This Service Information bulletin and attachment supersedes SI B11 10 12 dated **January 2013**.

N20 Engine: Repeated Juddering or Surging While Accelerating

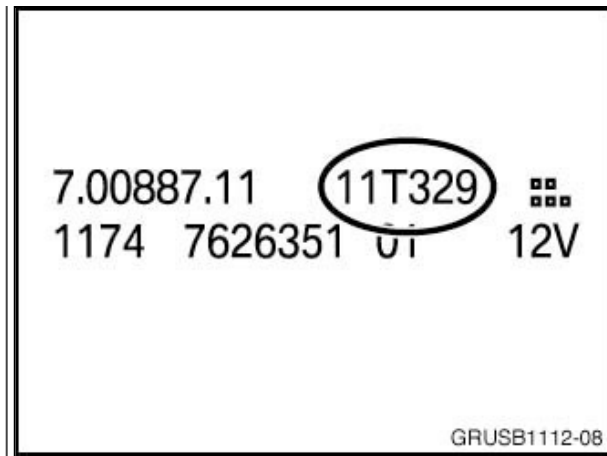
The date code located on the side of the EPDW needs to be 12T158 or greater.

If the date code is 12T157 or lower, the EPDW will need to be replaced.

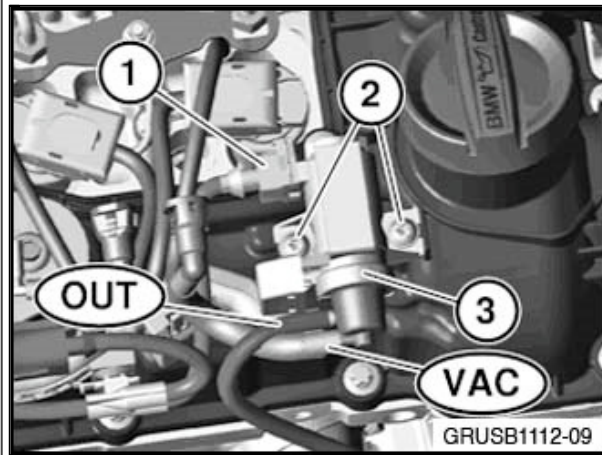
Refer to the illustration.

4. Remove the electrical connector (1).
5. Remove the screws (2).
6. Remove vacuum lines marked "OUT" and "VAC."
7. Remove EPDW.
8. Install the new EPDW, connectors and vacuum lines. Install and torque the attaching screws to 3 Nm (2).
